**Subject: Beaver Valley Power Station, Unit No. 1 and No. 2
BV-1 Docket No. 50-334, License No. DPR-66
BV-2 Docket No. 50-412, License No. NPF-73
Response to Bulletin 2001-01 Circumferential Cracking of Reactor
Pressure Vessel Head Penetration Nozzles**

Attachment A
BVPS Response to NRC Bulletin 2001-01

Reactor Vessel Configuration
Typical Pictorial for Beaver Valley Units

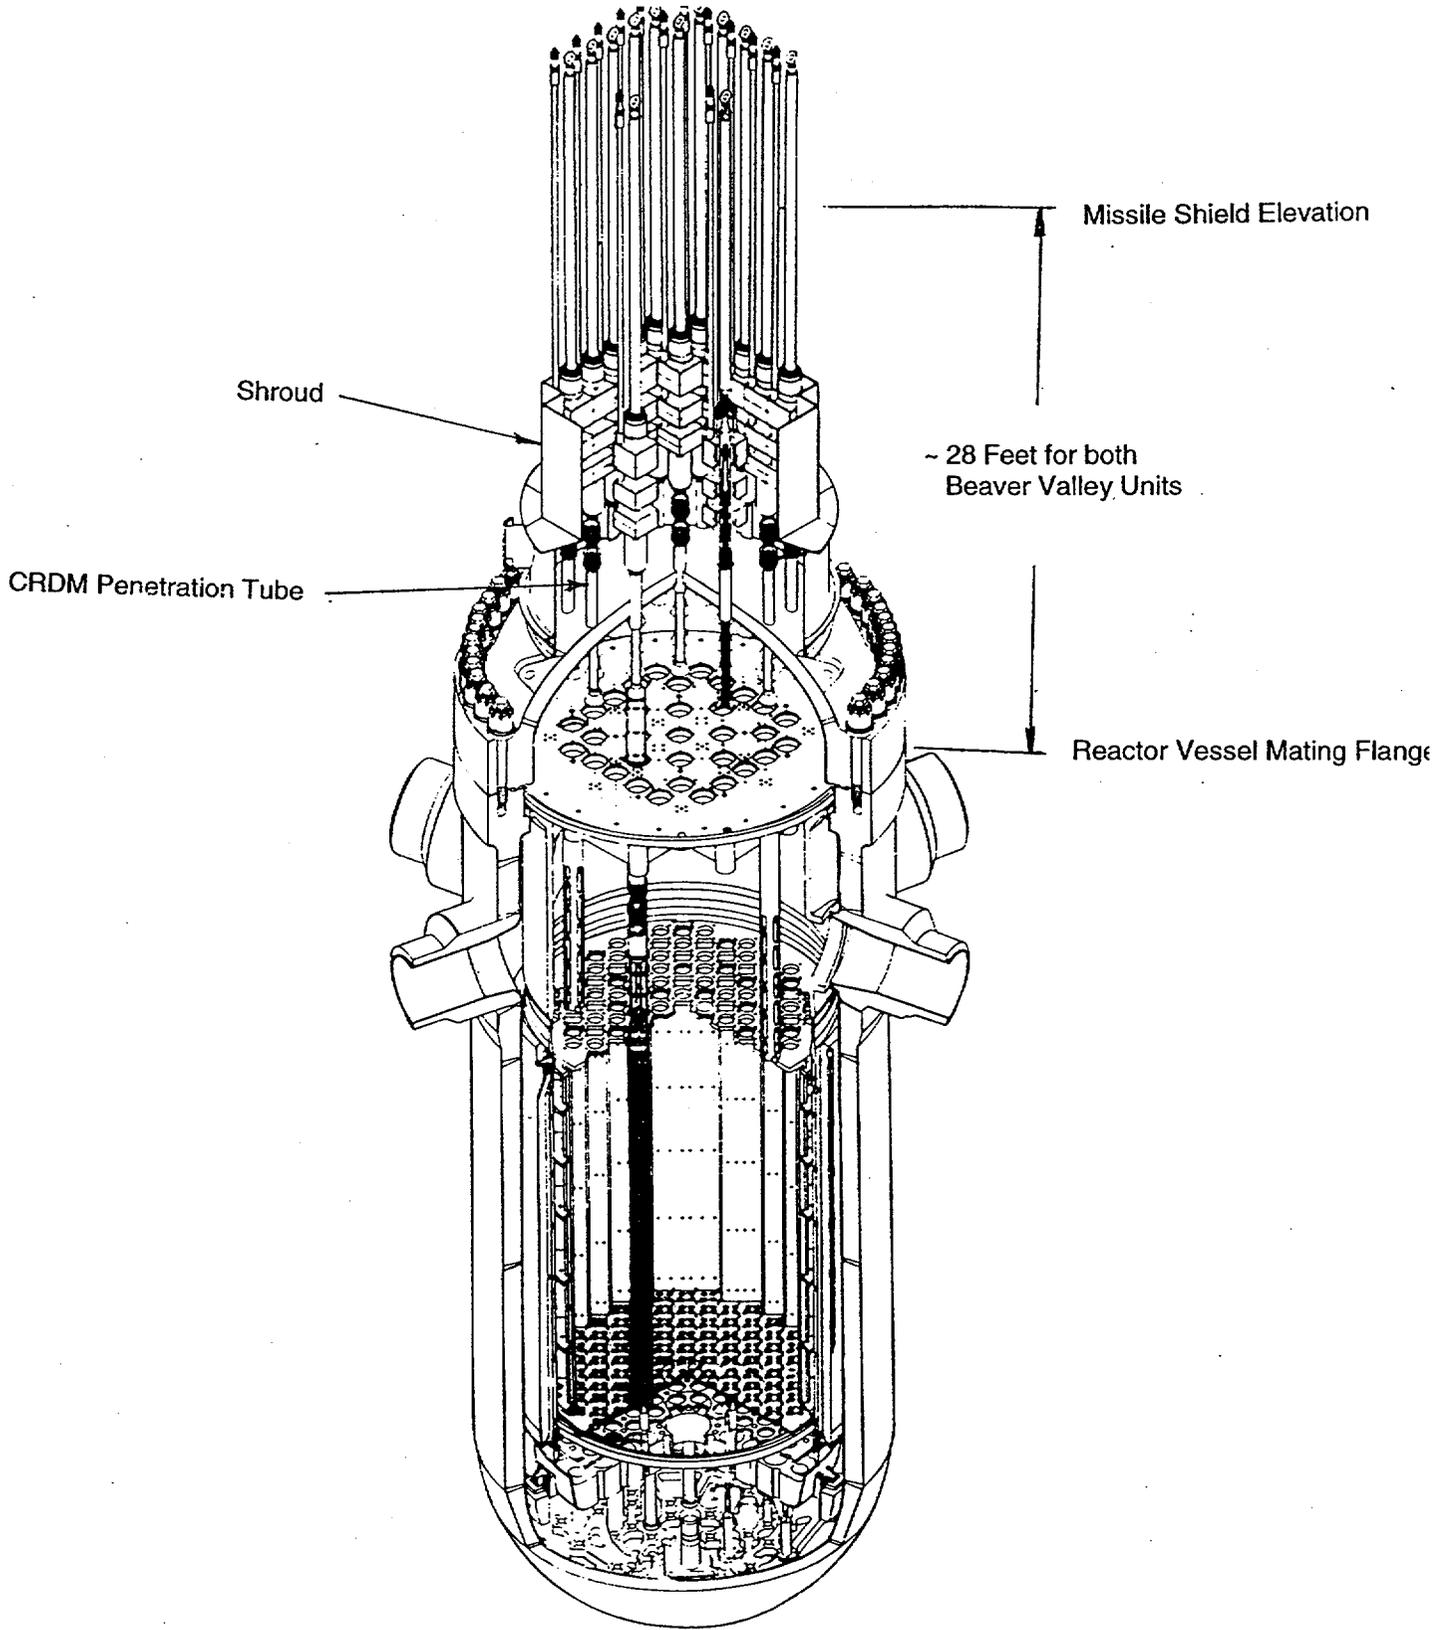
- 1.e Provide a description of the configuration of the missile shield, the CRDM housings and their support/restraint system, and all components, structures, and cabling from the top of the RPV head up to the missile shield. Include the elevations of these items relative to the bottom of the missile shield.

The attached sketch is a pictorial representation of the configuration at both Beaver Valley Unit 1 and Beaver Valley Unit 2. The major elements of the CRDM system are depicted in a pictorial fashion along with the relative elevation of the missile shield. Detailed site-specific drawings are available at the site if additional information is necessary.
